IOWA ELECTRIC LIGHT AND POWER COMPANY

Our submittal of October 13, 1977, forwarded a report entitled, "Design and Safety Evaluation for Replacement of Spent Fuel Pool Storage Racks." Additional information was provided by submittals dated December 20, 1977, March 14, May 11, May 15, June 6 and June 19, 1978. Transmitted herewith is an application for amendment of the previous submittals (hereinafter collectively referred to as the "DAEC submittal").

This amendment to the DAEC submittal describes the temporary installation of two 8 x 10 spent fuel storage racks manufactured for Boston Edison's Pilgrim I plant in the Duane Arnold Energy Center (DAEC) spent fuel pool. The temporary installation of these racks is necessary to allow the discharge of all fuel from the reactor to facilitate repairs to the recirculation riser nozzle safe end. All conditions in the previous submittals apply to this amendment.

FIGURE 1

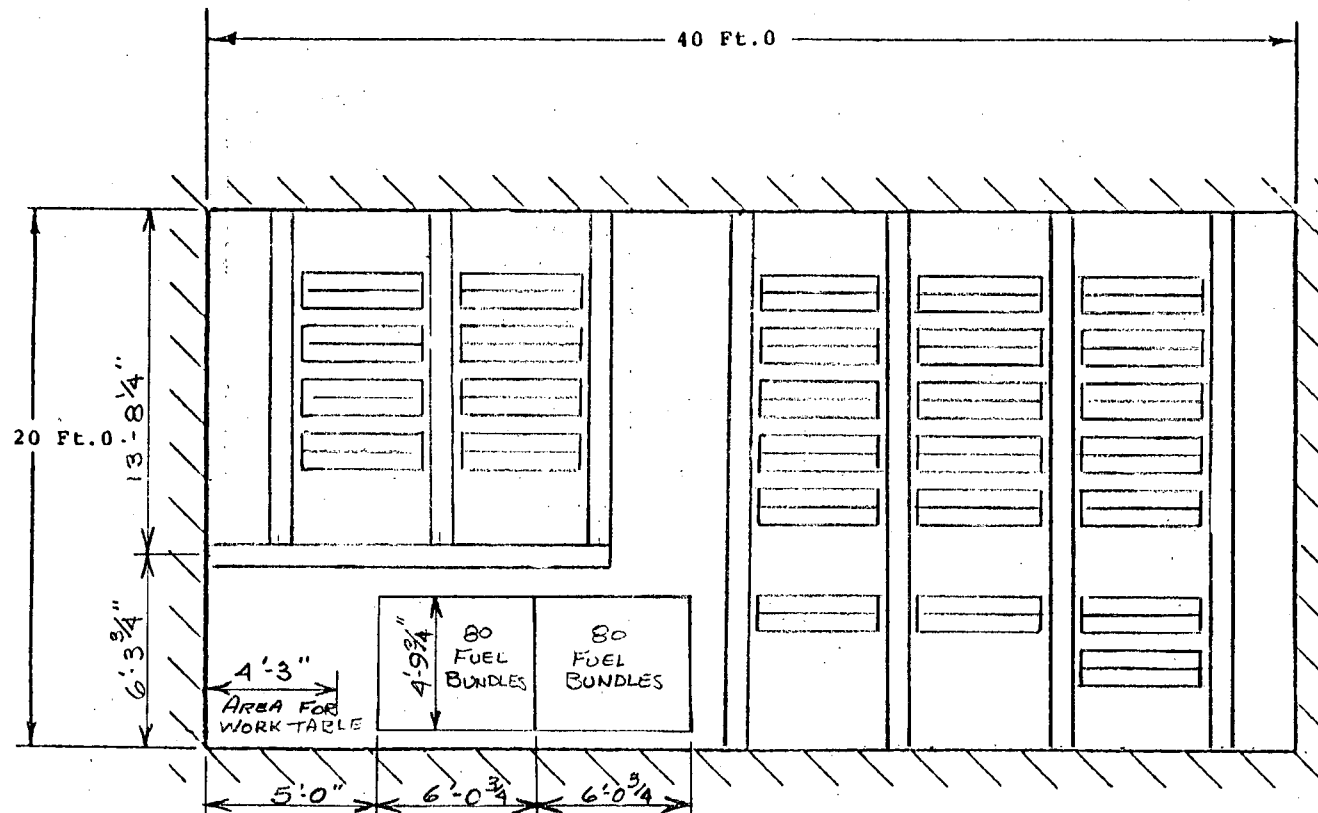
The temporary racks are of the Programmed & Remote Systems Corporation standard design for storing General Electric fuel and, except as noted below, are of the same design as the racks proposed for permanent installation in the DAEC submittal. The two racks will be placed in open areas in the fuel pool as shown in Figure 1. The temporary racks will have no effect on the existing racks in the pool nor will the existing racks affect the two temporary racks. No alterations to existing racks will be made. We have evaluated the effects of the physical differences upon the analyses results as reported in our application.

The current unused DAEC normal storage capacity is 206 bundles. The core offload, of 368 bundles, requires 162 additional storage locations. This amendment proposes the use of two 8 x 10 temporary racks for 160 additional locations. Two bundles will be stored in the fuel preparation machines.
